Service Bulletin

PRELIMINARY INFORMATION

Subject: HVAC Blower Motor Is Noisy Or Vibrates

Models: 2014 Chevrolet Silverado 1500
2015 Chevrolet Silverado, Suburban, Tahoe
2014 GMC Sierra 1500
2015 GMC Sierra, Yukon Models

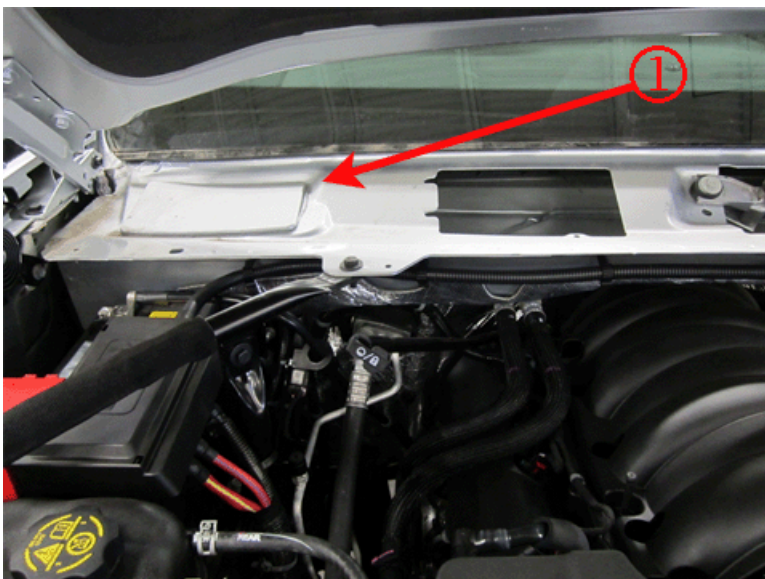
1. Perform normal water testing diagnostics while the HVAC is running (high blower and in fresh/outside air mode). Inspect for any water leaking past the plenum cover cap, as shown below (1). Water could drip off the bottom of the plenum cover cap (1) into the HVAC fresh air inlet, as shown below (2).

2. If water is leaking past the plenum cover cap (1) it will need to be removed and resealed. While the plenum cover cap is removed also complete the next steps to add a low pressure drop fine snow resistant screen over the fresh air inlet to prevent snow ingestion.
3. Install a 12" x 12" snow resistant screen material over the HVAC fresh air inlet (2), as shown below. The water resistant screen can be ordered from Outerwears at www.outerwears.com or by calling 800-967-3450. When searching for the product on the website, use part number WR12 and then select color Black (WR12BK).

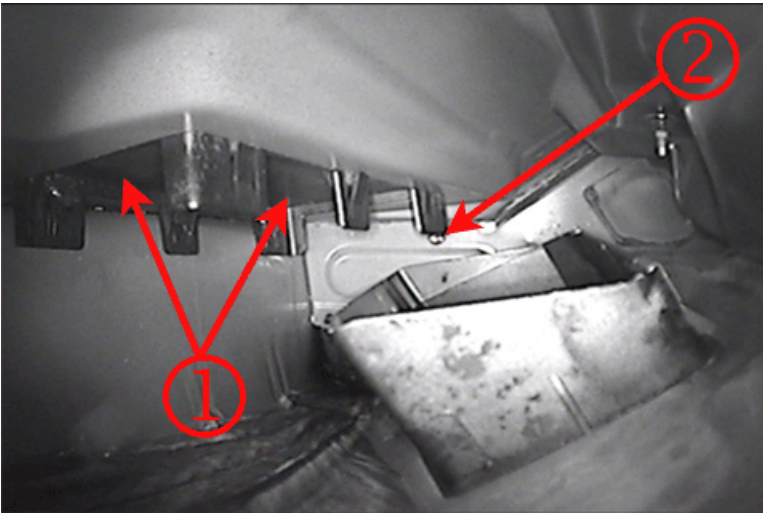
4. Secure the snow resistant screen with 7 clips, part number 11588650, to the HVAC fresh air inlet (2), as shown below.

5. Reinstall plenum cover cap using Kent air dry sealer or RTV around the perimeter of the plenum cover cap.
6. Confirm there are no leaks by repeating step 1.
